50-329/330 OM, OL
midland

Exhibits During
Oral Deposition of
Frank Rinaldi

SUBJECT: MIDLAND NPP - DISCOVERY QUESTIONS
REQUEST FOR INFORMATION, FSAR REVIEW

Evaluation of Response to 10CFR 50.54(f) Request

MIDLAND PLANT UNITS 1 & 2	
CONSUMERS POWER COMPANY	
CLASS & SKETCHES	
FIGURE 1	DATE 5/10/57

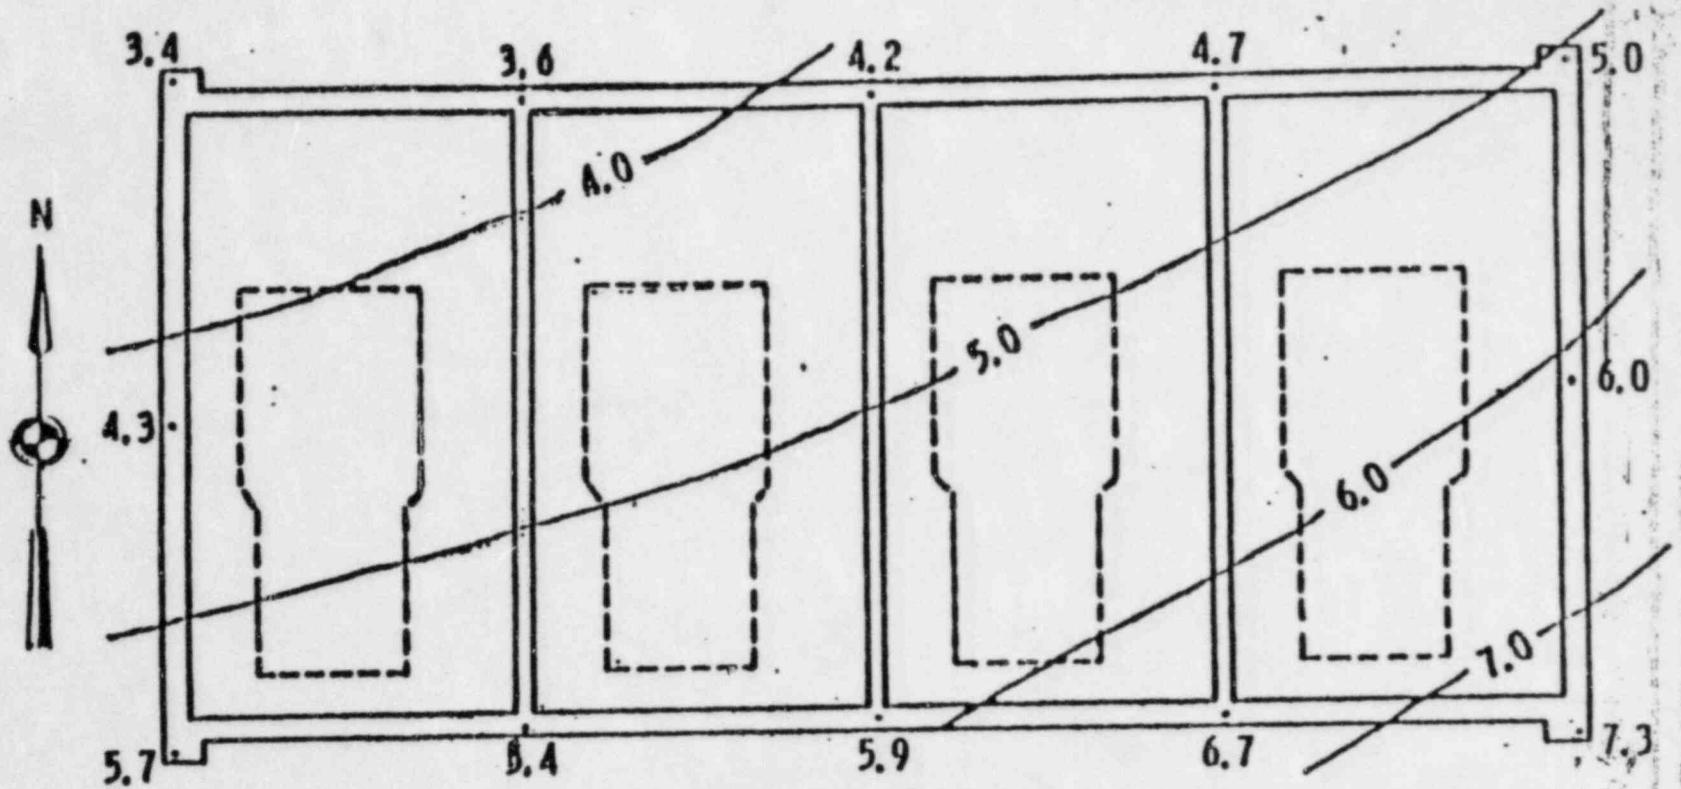
The affected structures are shown in Figure 1.

FIGURE 2

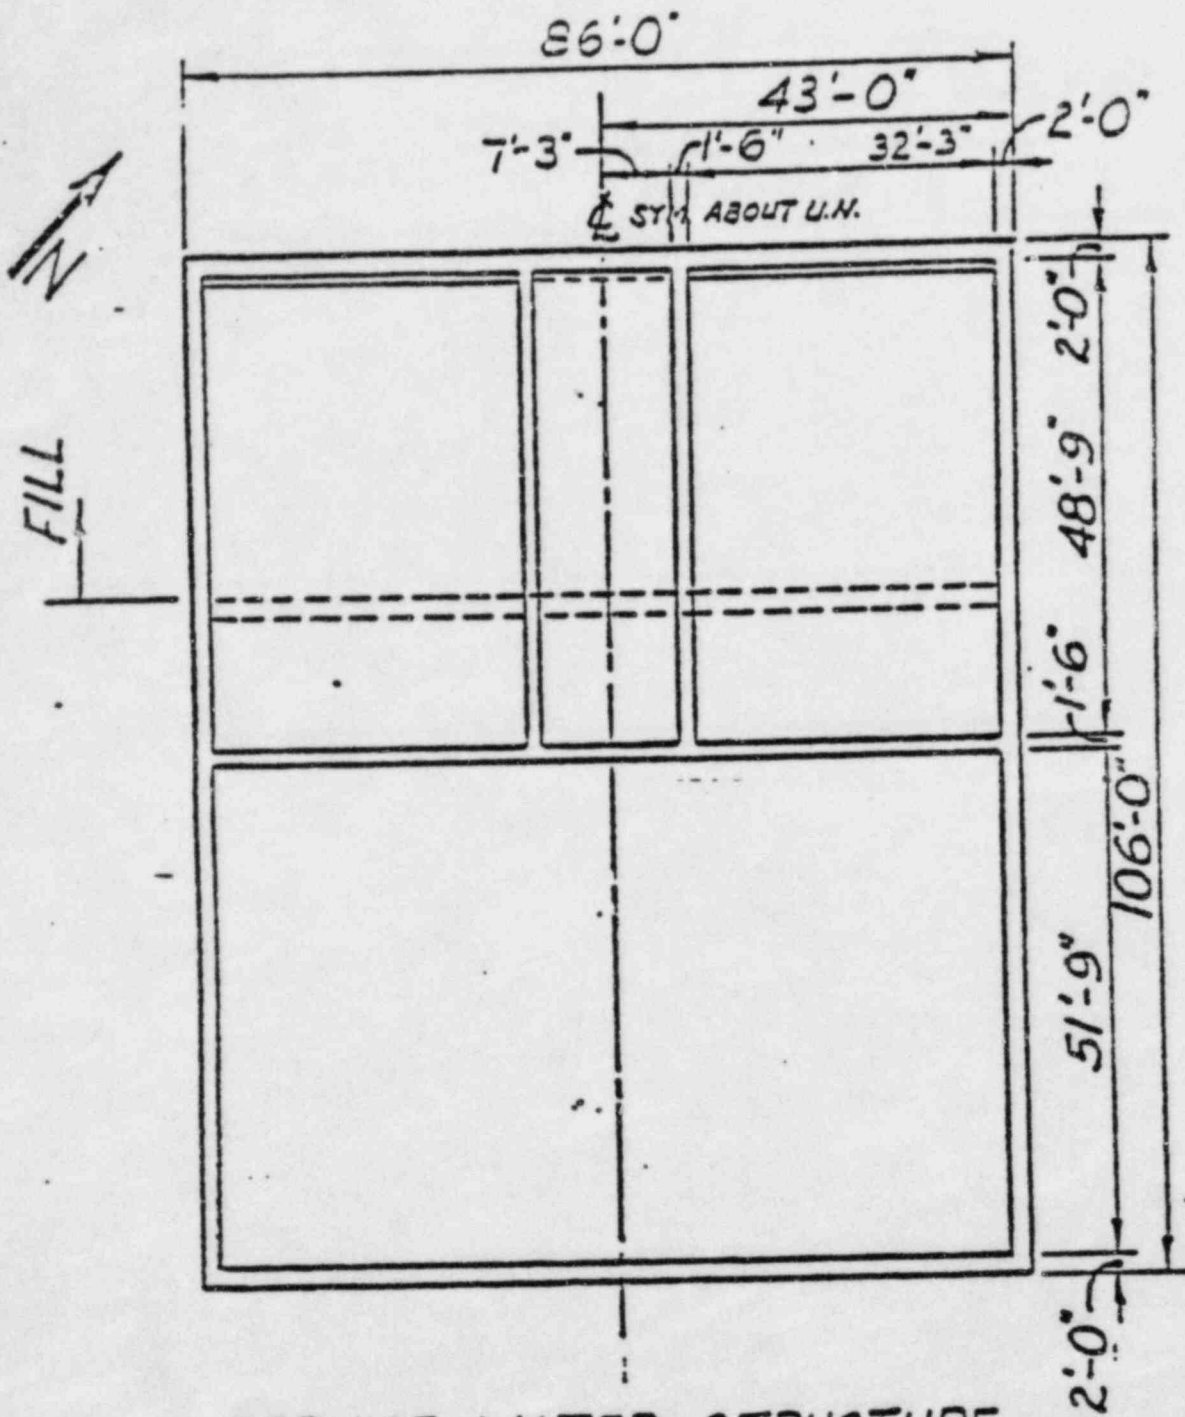
It was observed that there was excessive settlement of the diesel generator building. The contours of the settlement monitoring are illustrated in Figure 2. It can be seen that the differential settlement approximates 4 inches.

FIG. 9

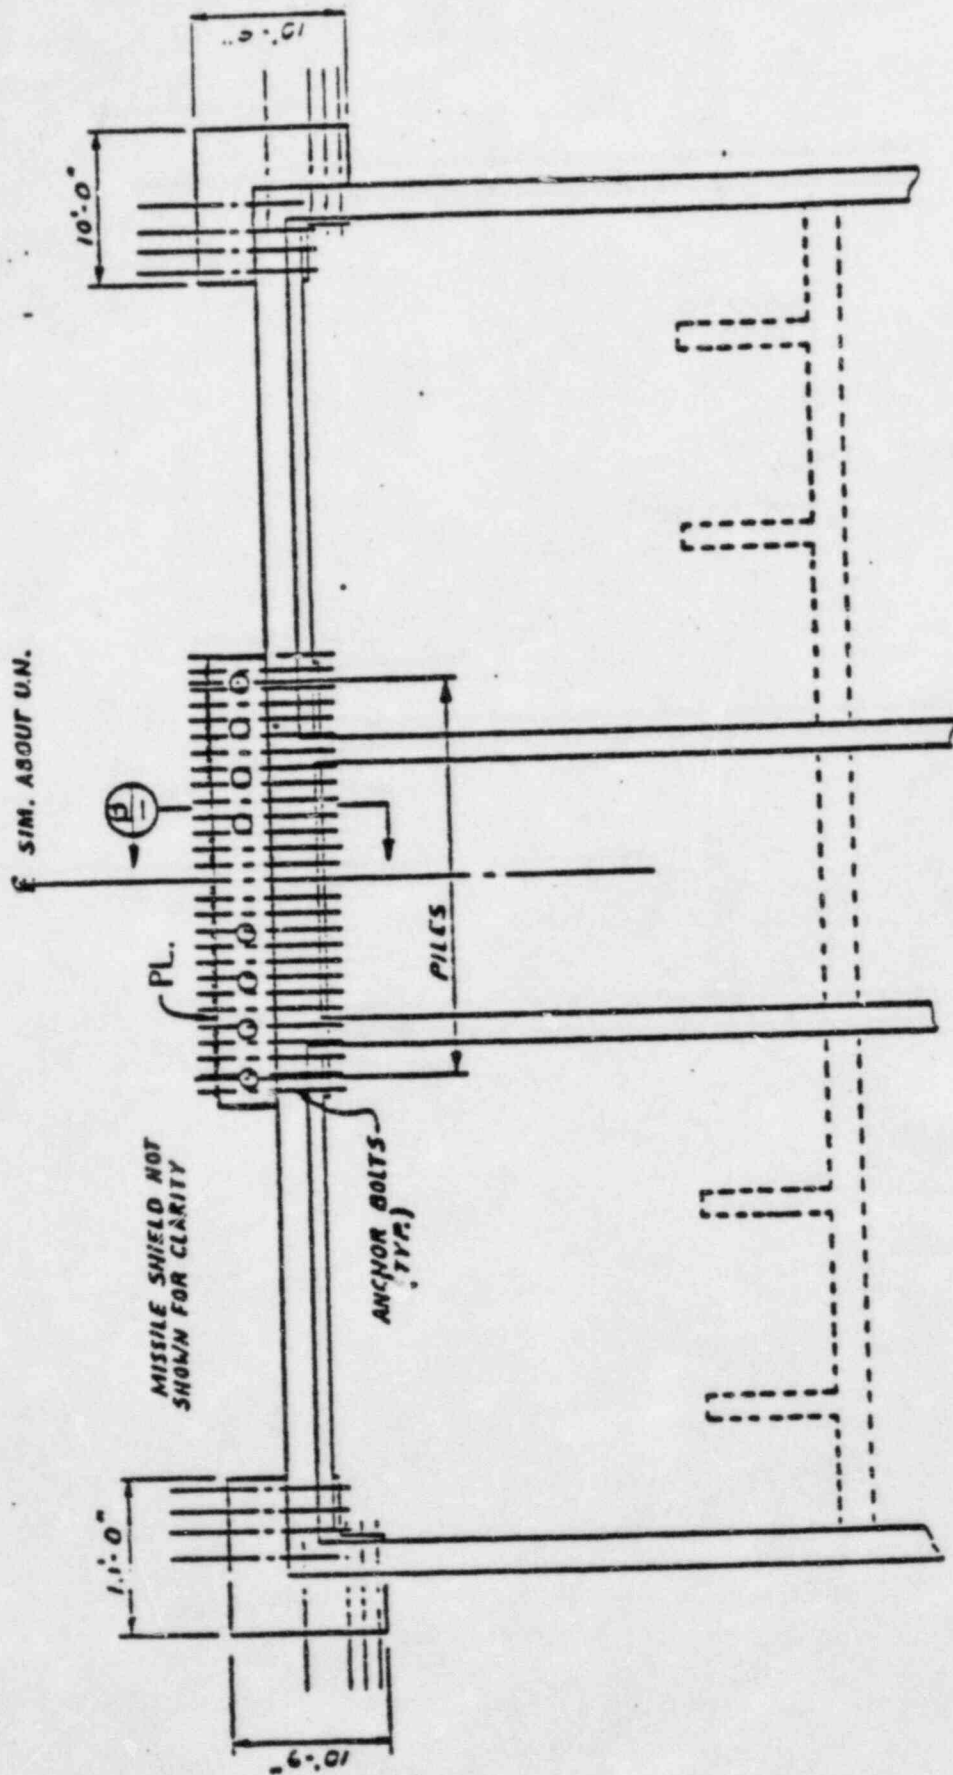
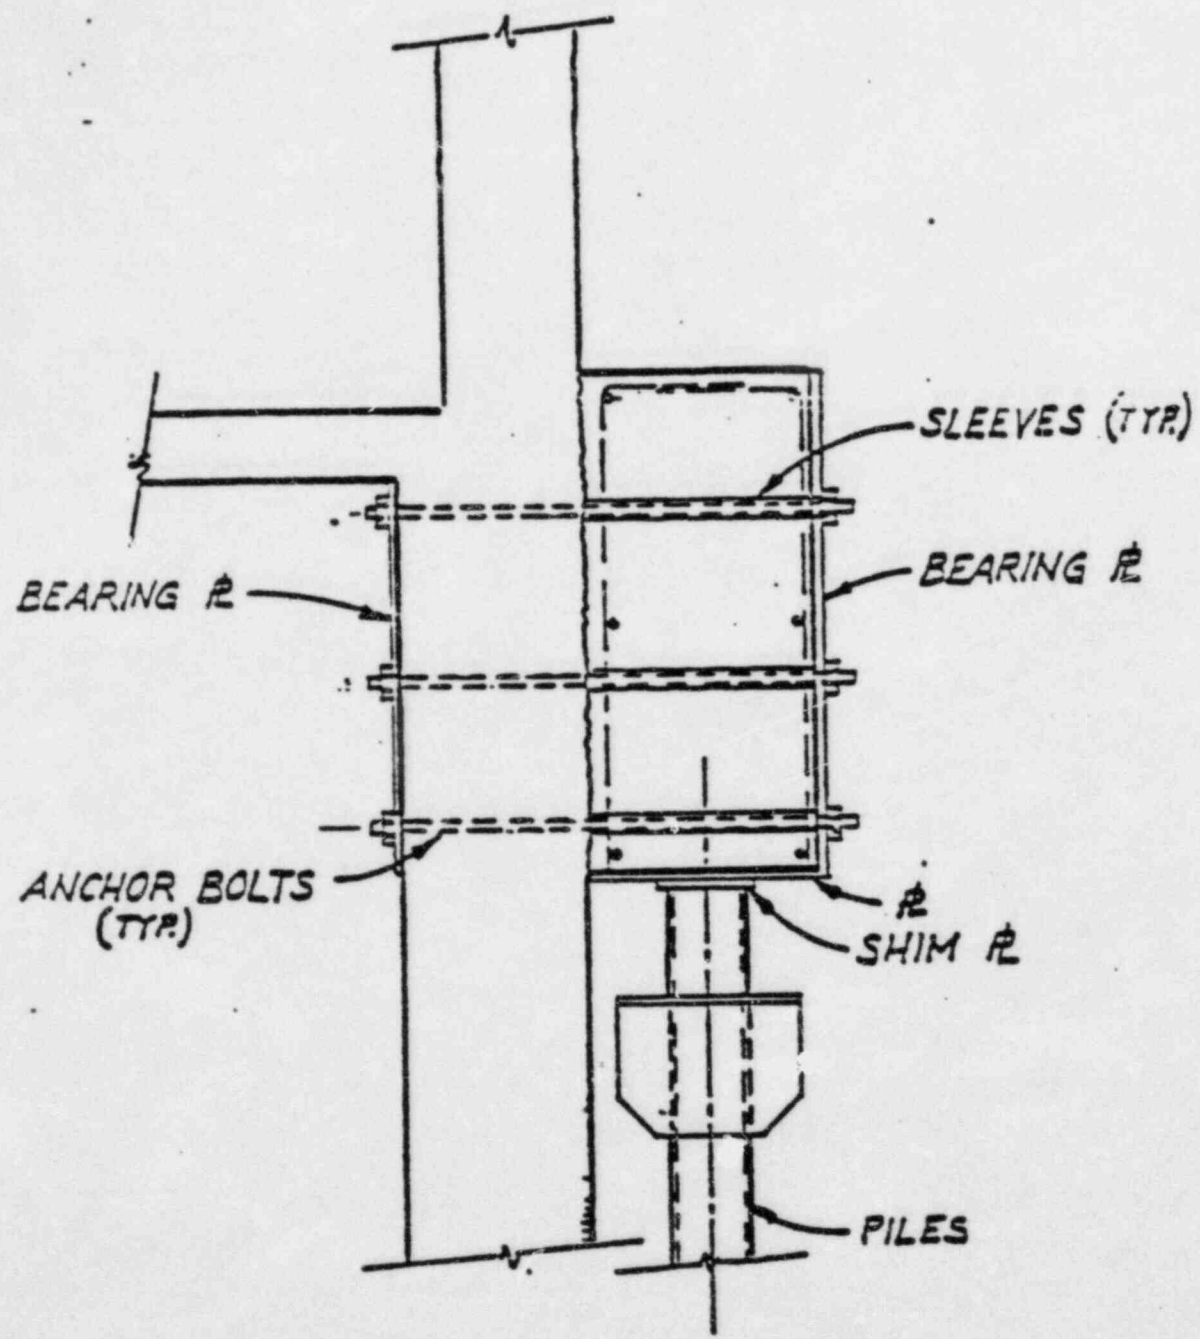
- a. The corrective action does not provide the type of foundation support that was considered in the original design, which provided stable solid soil support along the foundation of the structure. The corrective action only provides concentrated supports along the wall through the use of piles, corbels, and bolts.

- b. The method of attaching corbels by using long longitudinal bolts through the walls requires the bolts to resist bending forces. This is not an effective way of utilizing bolts, since bolts provide low strength in the bending mode. Other corrective design methods, that more closely comply with the design intent, should be considered and compared.

Figures 9, 10 and 11 show the plan and details of the piles. A total of 16 piles is planned at this time. The piles will have a capacity of 100 tons and are designed as bearing piles to carry only vertical load. The piles will be pipe piles filled with concrete. They will be pre-drilled through the fill and driven into the glacial till. The length is expected to be approximately 50 feet.
